SPIRE-RAL-NOT-001940 v2

To:Spire Project

## **QM DRCU INTEGRATION**

## MAPPING OF DCU CONNECTORS FROM FLT TO QM.

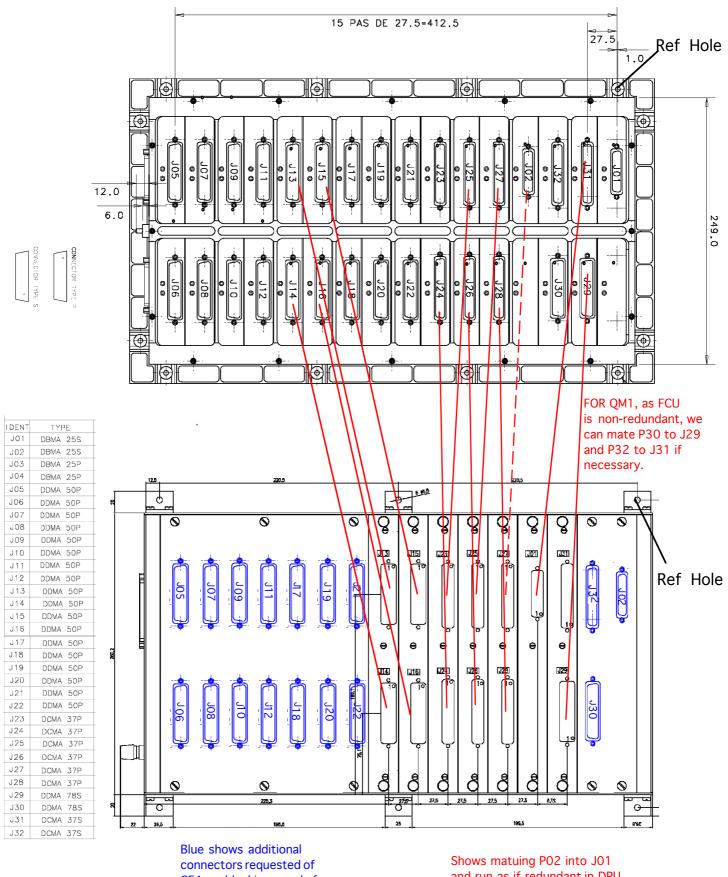
Let this bend cut corner and with lower height of unit check that J17 and J19 will reach across to QM posn.

CEA on blanking panels for EMC and cable storage.

and run as if redundant in DPU. (This swop could be done on DPU end alternatively.)

CONCLUSION: AS FAR AS THE DCU IS CONCERNED, THE QM1 CAN USE THE SAME CABLES AS THE FM, PROVIDED SLIGHT SIDEWAYS SHIFT ON LINKS 13-16 is OK.
